Summary

The proposed project presents a number of unacceptable risks which have not been adequately assessed in the EIS, or for which insufficient mitigation is proposed. Assessed in total, these risks warrant refusal of the project. They include:

Figure 3-5: Geological Map: Barcaldine – Alpha Region (DERM, Per Comms)

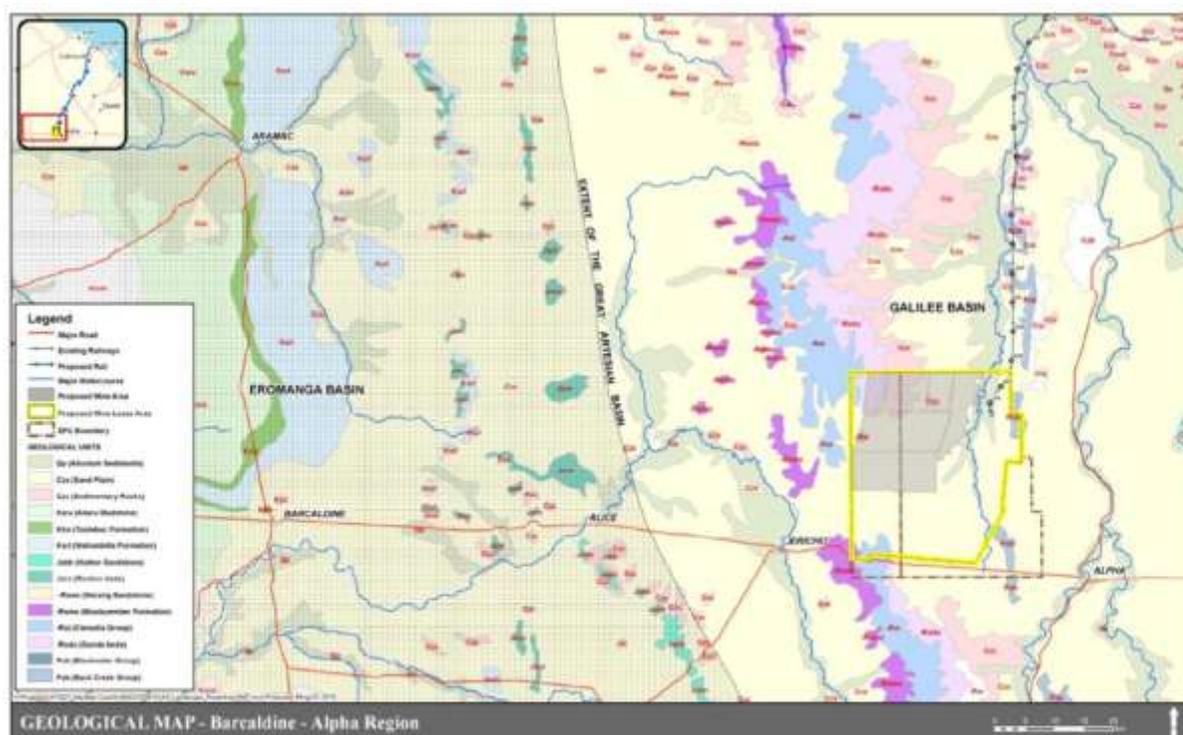
The above map from the EIS indicates that the 'Extent of the Great Artesian Basin' lies around 30-40 km west of the Waratah Coal 'proposed mine lease area'. The source of the above map is named as 'DERM, Per Comms', but no reference is provided in the Reference list on p.10-1. However, it seems that the basis for the above map is the 1972 1:250 000 map available from the Geoscience Australia website,²¹ from which a screen shot of the roughly matching area is provided below. A full image of this map is provided in Appendix E. Note however that there is no such line on the Geoscience map indicating the 'Extent of the Great Artesian Basin'.

COMMENT/SUGGESTION: This Appendix and all related chapters and section of the EIS must be thoroughly revised.

The proponent must explain how the incorrect map and description of the boundary of the GAB in relation to the proposed development has affected the analysis of the likely impacts from the proposed development.

Portion of 1972 'Jericho' 1:250 000 geology map, sheet SF55-14, from Geoscience Australia

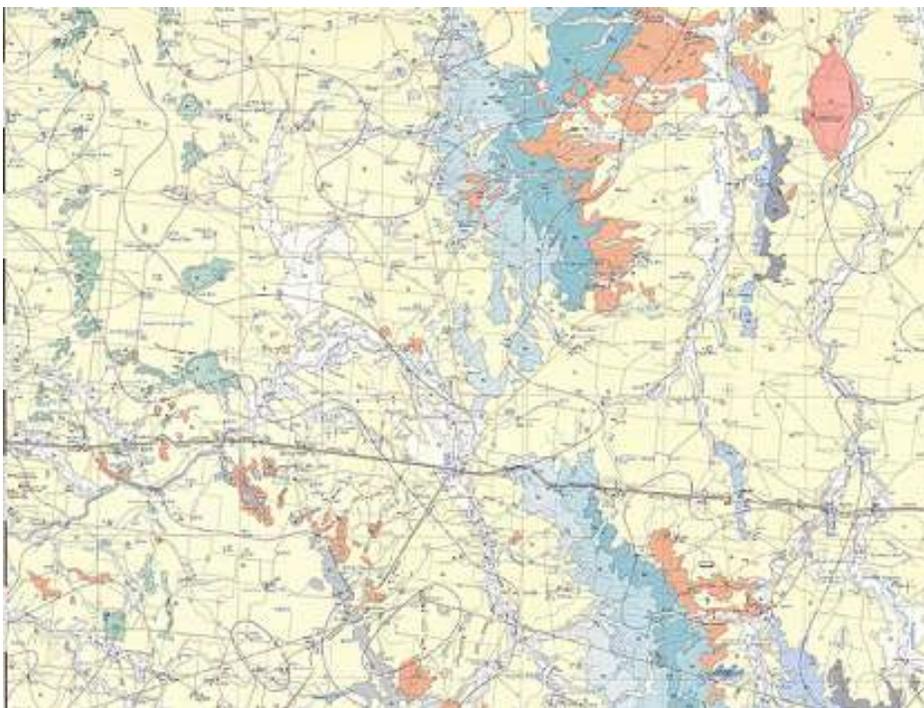
While it is very difficult to read the legend on the map provided in Appendix 14, the original Geoscience map reveals that the formations north and south and slightly overlapping the Waratah Coal tenement area include the 'Lower Triassic Dunda Beds' and the 'Lower to mid Triassic Clematis Sandstone', among others (see original for detail on this).²² The Stratigraphy of the Galilee Basin provided in another section of the EIS helps to explain the relationship between these geological beds:

Figure 7. Galilee Basin Stratigraphy

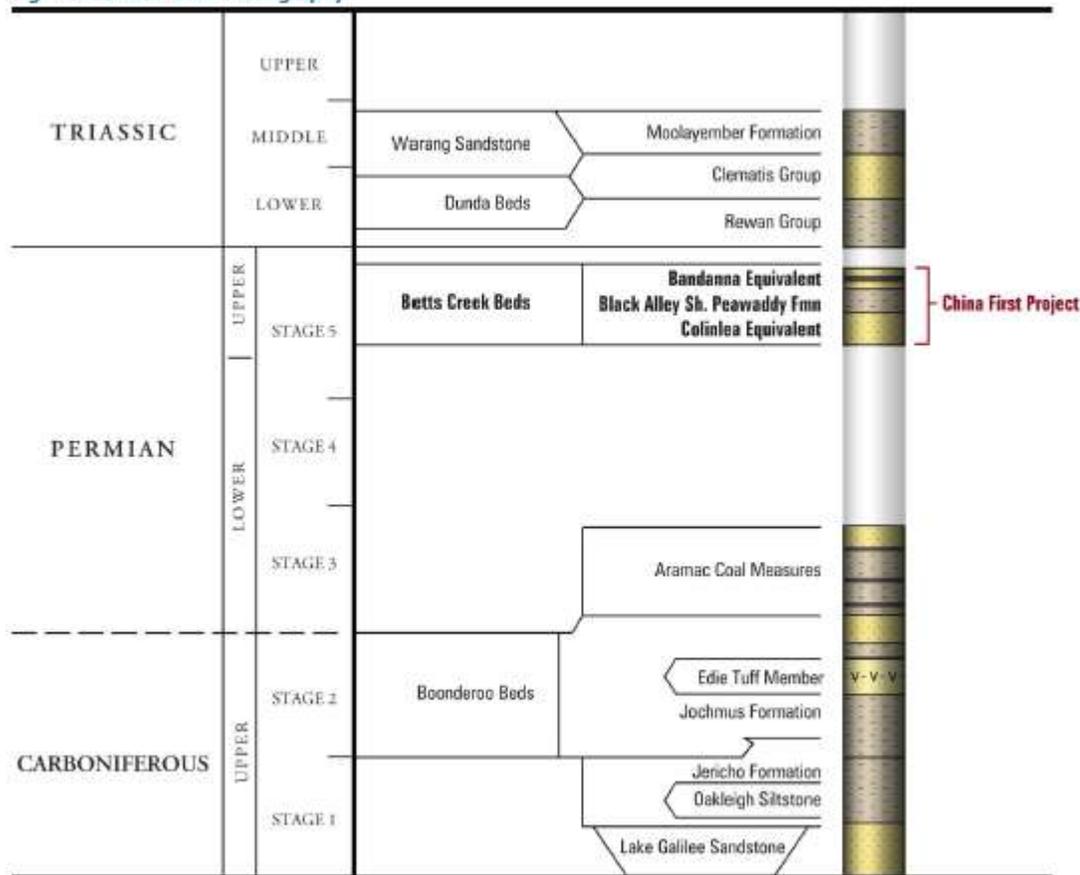
This figure illustrating the Galilee Basin stratigraphy, documents that both the Clematis Sandstone and the Dunda Beds over-lie the coal seams that the proponent wishes to extract.

A map from the EIS showing an overlap between the proposed development and the GAB (Vol 2 Ch 8, p.229)

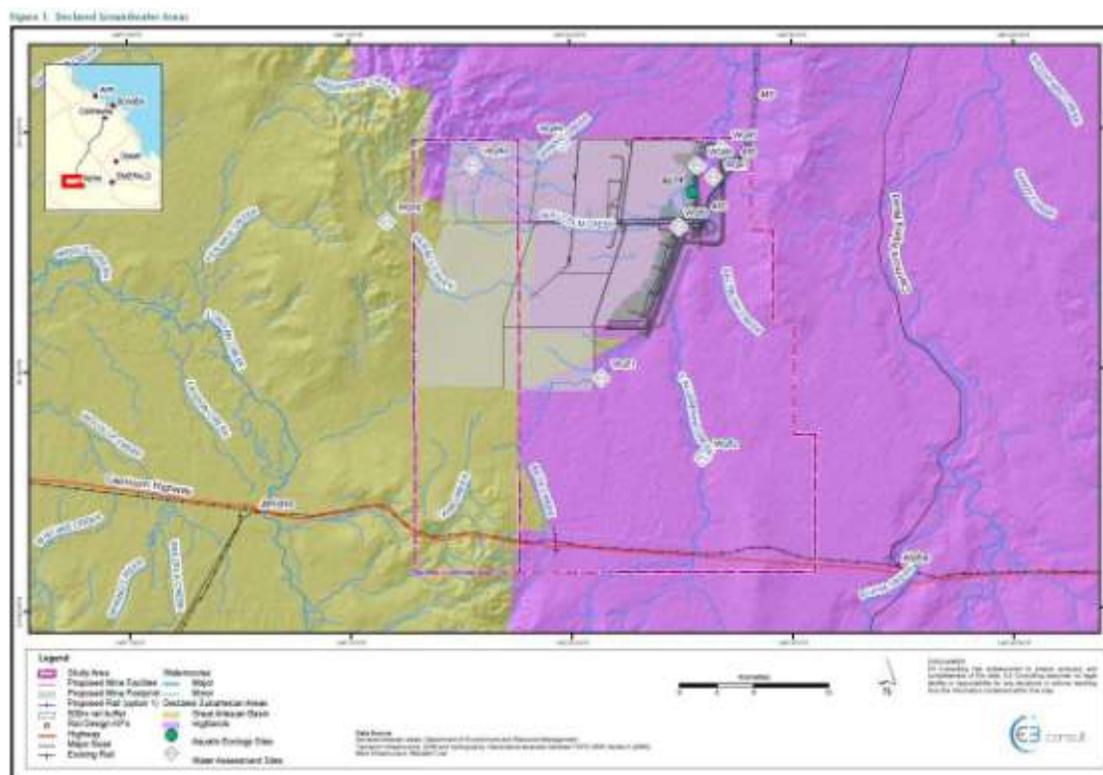
While the inclusion of the above map in the EIS suggests that the proponent has acknowledged the widely accepted boundary of the GAB to some degree, it still appears that the *analysis* of groundwater has been based on an incorrect boundary (the map in Appendix 14). Thus it remains a question as to the relevance and reliability of the analysis. For instance, it is worth highlighting again the conclusion from the consultant's report, section 8, Appendix 14, p. 8-1:

COMMENT/SUGGESTION: Independent hydrogeological research must be undertaken for the area of concern. In particular, more accurate mapping of the Clematis Sandstone and other GAB elements must be undertaken and publicly presented before any assessment is made of the impacts from the proposed mine. The important details of the groundwater resources in the region, and the likely impacts from the proposed mine, must be understood before any further application to proceed is put before the government.
